TO: MEMBERS OF THE PLANNING COMMISSION
FROM: DAN COMMER, AICP – PLANNER
SUBJECT: 21111 MEADOWBROOD ROAD WOODLAND PERMIT
DATE: OCTOBER 22, 2024

WOODLAND REVIEW

Re: 21111 Meadowbrook Road – Woodland Review (PBR22-0569)

GRADING PLAN

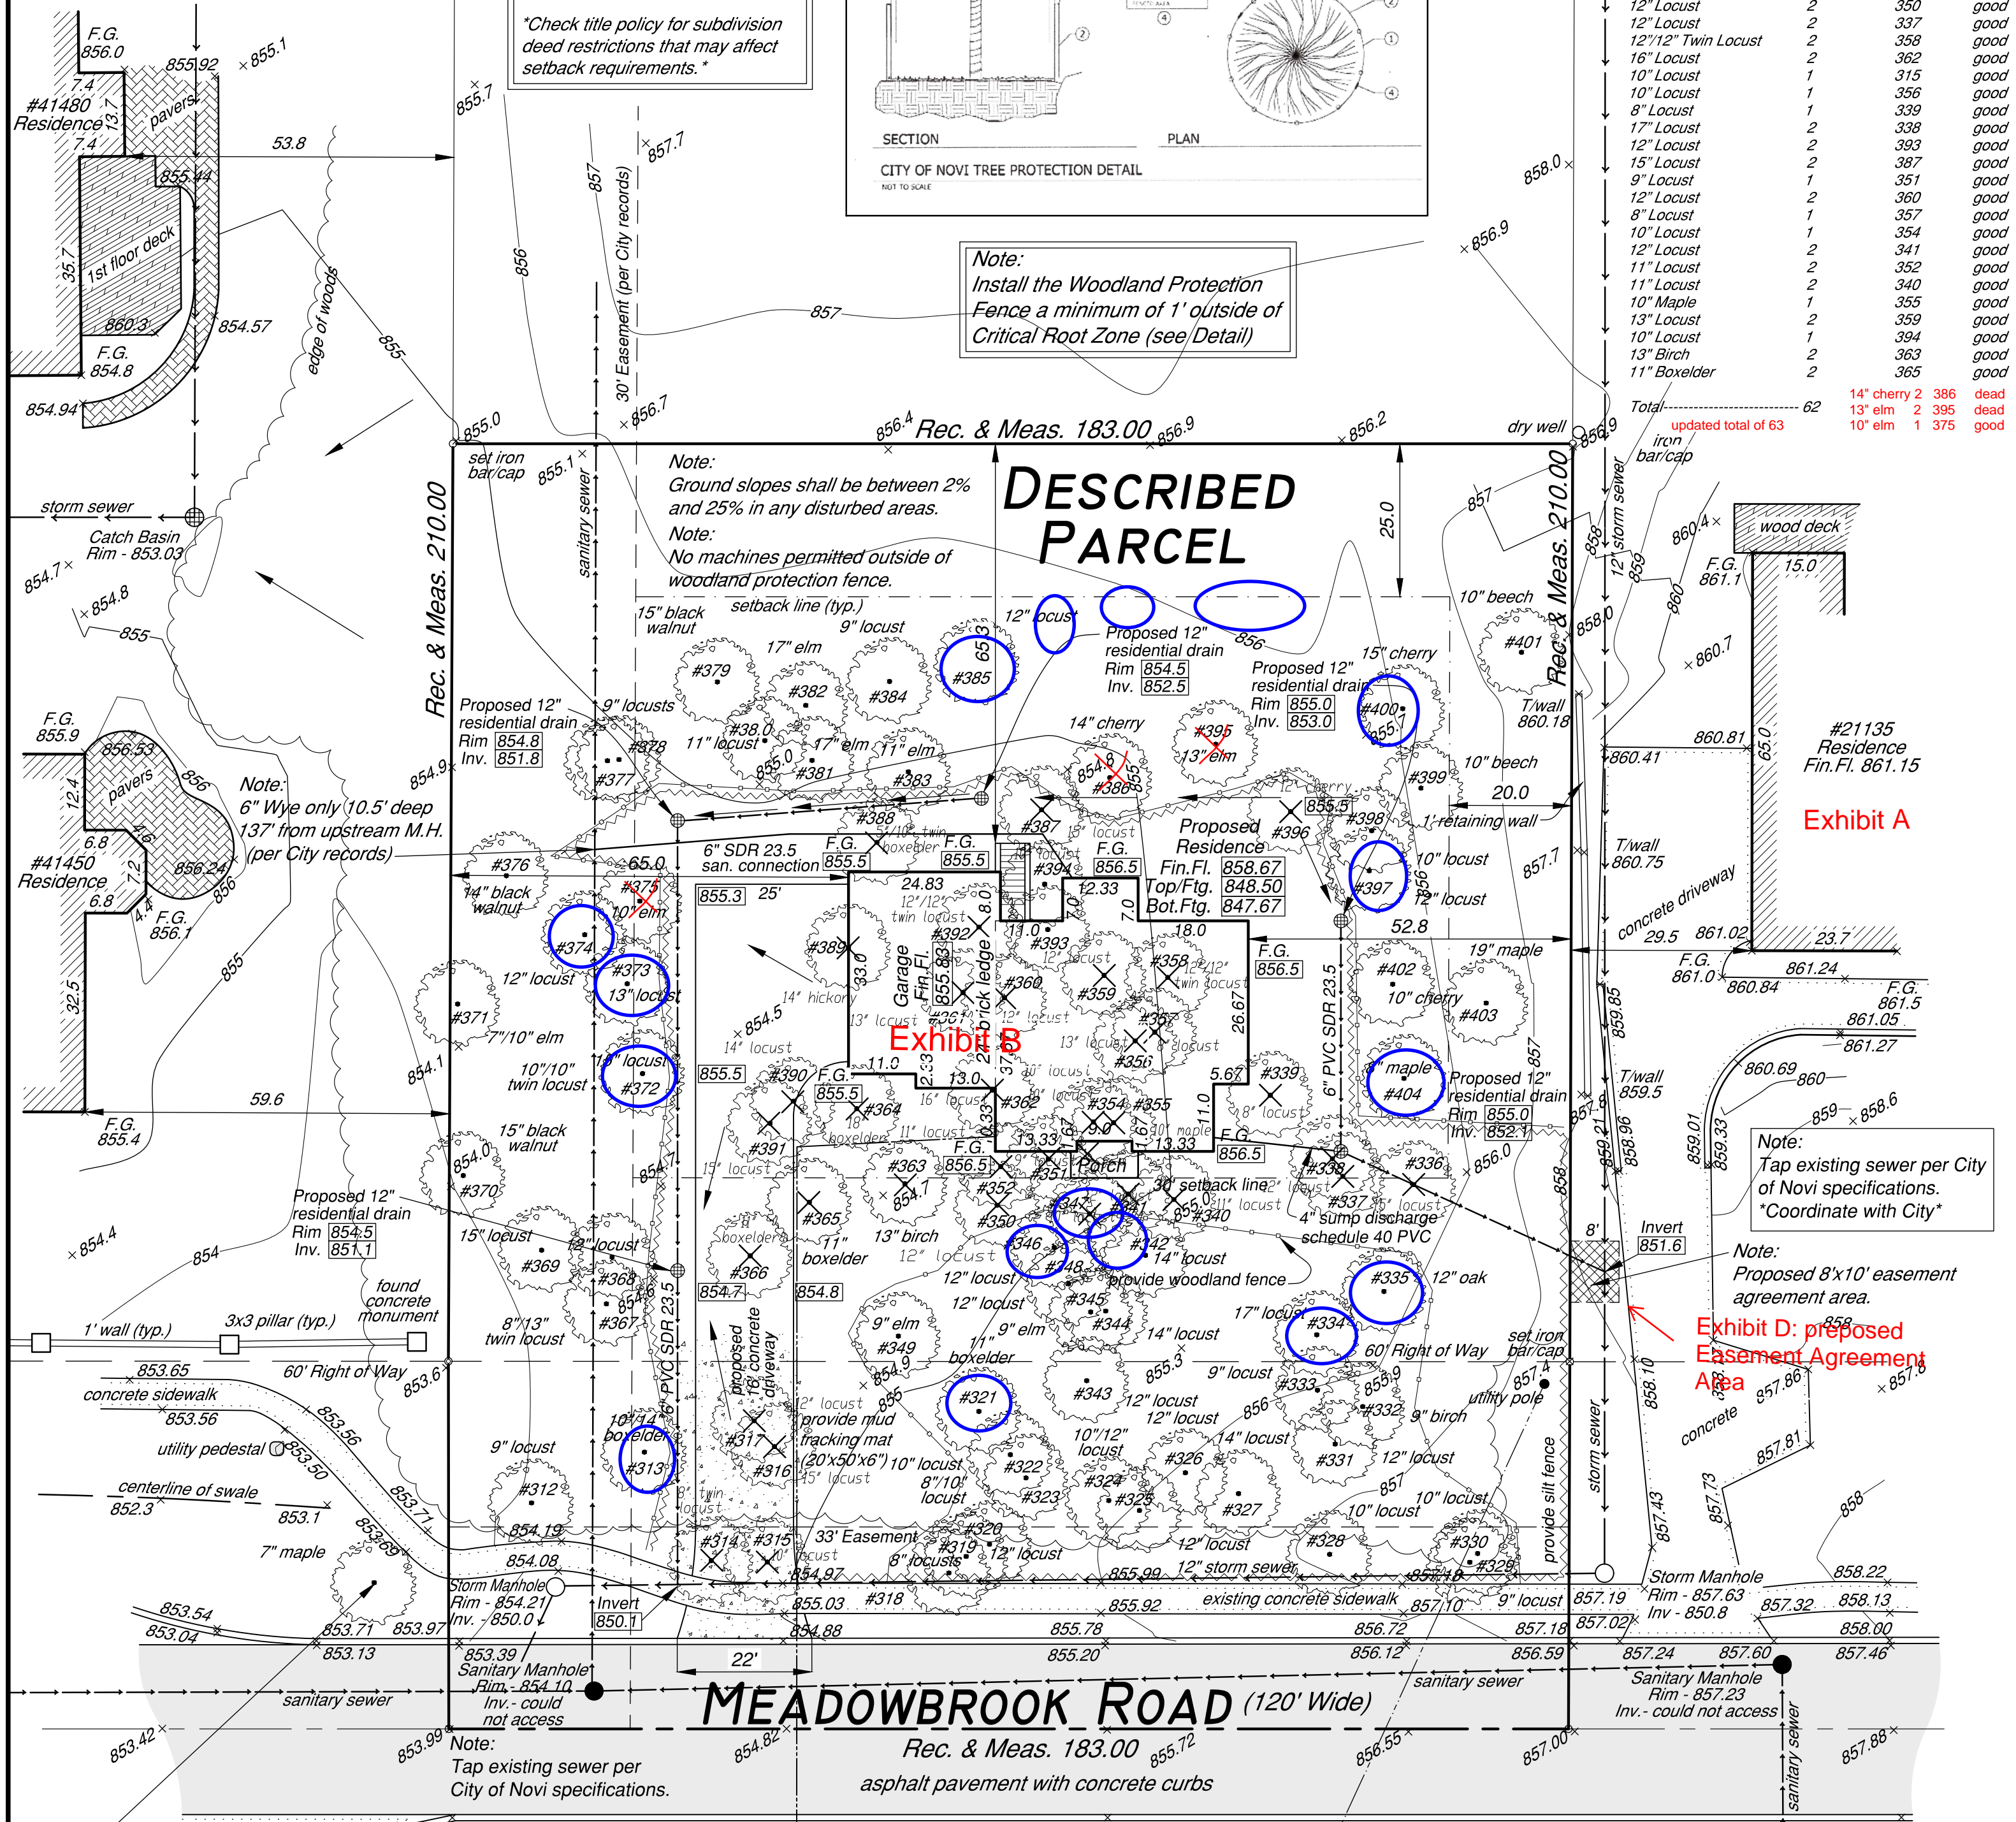
Merjent, Inc. (Merjent) has conducted a post-inspection review of the single-family residential plot plan for 21111 Meadowbrook Road (site; dated 1/19/2023 and February 14, 2023) prepared by Jakobson and Associates, P.C. Merjent reviewed the plan for conformance with the City of Novi's (City) Woodland Protection Ordinance, Chapter 37. The site (parcel 50-22-35-400-071) contains City-regulated woodlands (Figure 1). The applicant removed trees prior to Merjent's site visit on July 12, 2024. Merjent conducted an additional review at the request of the City and the applicant for conformance with Section 37-9 of the City's Woodland Protection Ordinance. In conducting this review, Merjent reviewed additional correspondence between the City's Landscape Architect, Rick Meader, and the applicant as well as previous reviews conducted by the Davey Resource Group (DRG). DRG conducted three reviews prior to recommending approval of the plot plan on February 17, 2023.

Merjent understands that the City's Landscape Architect conducted an on-site inspection of the approved tree removal on April 10, 2023. Photographs were provided to Merjent that showed multiple trees containing fill (soil) stockpiled and construction equipment stored and working within the critical root zone. These trees were identified in the plot plan as being protected (not impacted) from proposed construction activities. Section 37-2 of the ordinance defines a critical root zone as a circular area around a tree with a radius measured to the tree's longest dripline radius plus one foot. As stated in Section 37-9, impacts to critical root zones, or areas where critical root zones cannot be protected, should be considered as tree replacements and paid to into the City of Novi Tree Fund.

-
2. Trees on the south side of the property, for example Trees 313, 372, and 373, were found to have their northern critical root zones within the newly constructed driveway. Photos provided show the trees dripline being located directly above the newly constructed driveway.
 3. Trees on the north, west, and east side of property were shown to be free of soil stockpiling and construction equipment now that construction has ceased.
 4. Multiple tree diameter at breast height (DBH) measurements were collected and compared to the previous tree survey.

Western encroachment area showing Tree 383 with no machinery/soil present.

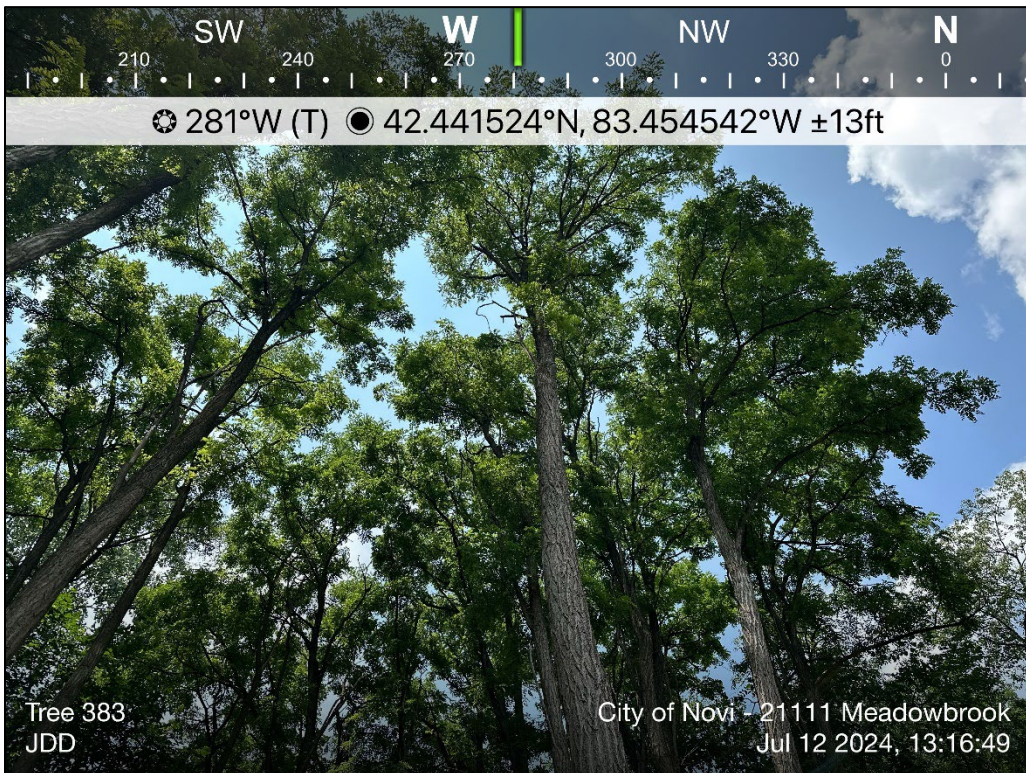
During Merjent's on-site review, it was found that the remaining black locust (*Robinia pseudoacacia*) trees not associated with the driveway construction appeared to be growing normally. However, tree uptake of water (impacted by compaction), root growth, and overall oxygen availability to the tree cannot be measured visually. This may not directly kill a tree, but it may result in overall reduced efficiency of sequestering carbon dioxide into woody growth, among other primary functions of trees. Merjent understands the conservative approach to considering the impacts that these additional construction impacts may have had on the trees noted for encroachment.
